1. Application Details Summary

Development Application No:	DA027/2020
Description of Development:	Extractive Industry - Ralston Quarry
Applicant:	Regional Group Australia c/o Groundwork Plus
Landowner's consent provided:	Yes
Local Government Authority:	Coonamble Shire Council
Determining Authority:	Western Regional Planning Panel

3. DA027/2020 Overview

This Addendum Assessment Report has been prepared by Coonamble Shire Council in response to the WRPP Record of Briefing. It references a letter received from Groundwork Plus dated 29 June 2021 on behalf of the applicant, that responds to the WRPP Record of Briefing. It also provides an assessment of the most recent issues raised by either the WRPP and / or Groundwork Plus in order for Council to provide a complete assessment of the proposed Ralston Quarry.

Source: Groundwork Plus letter dated 8 March 2021

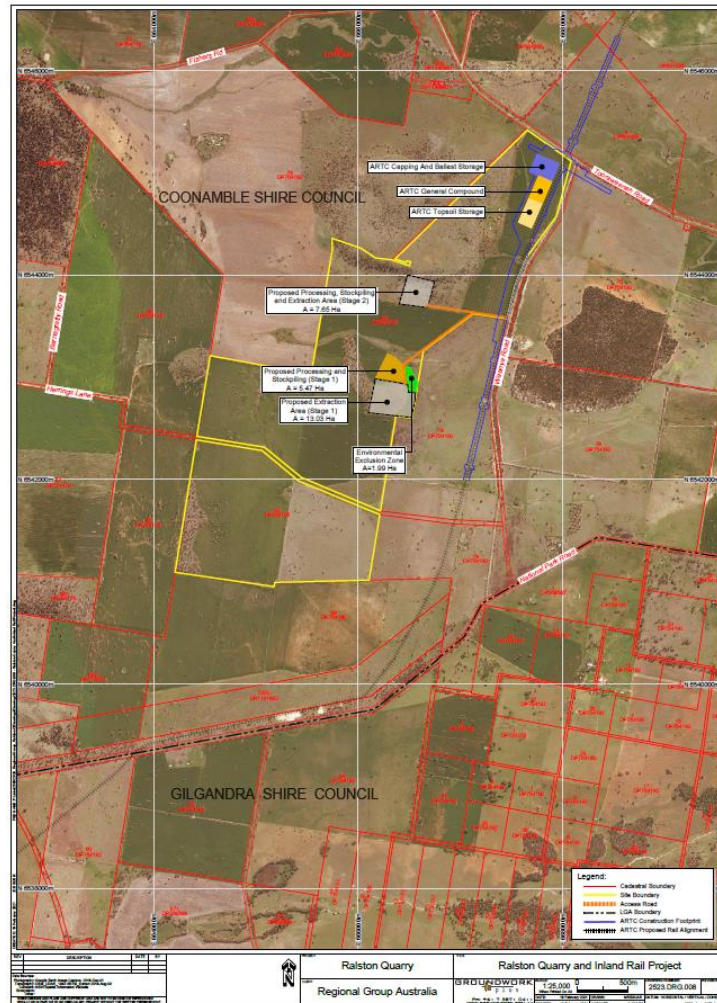
Coonamble Shire Council's Assessment Report of DA027/2021 for the proposed Ralston Quarry, dated 8 April 2021 included a layout plan of the proposed quarry operations and the ARTC material compound proposed under State Infrastructure Application No. SSI-9487 during Stage 1 quarry operations. This layout plan is repeated below for further consideration:

Having regard to the layout plan provided by Groundwork Plus, the Ralston Quarry would be located in very close proximity to the Inland Railway corridor and a planned ARTC material storage compound.
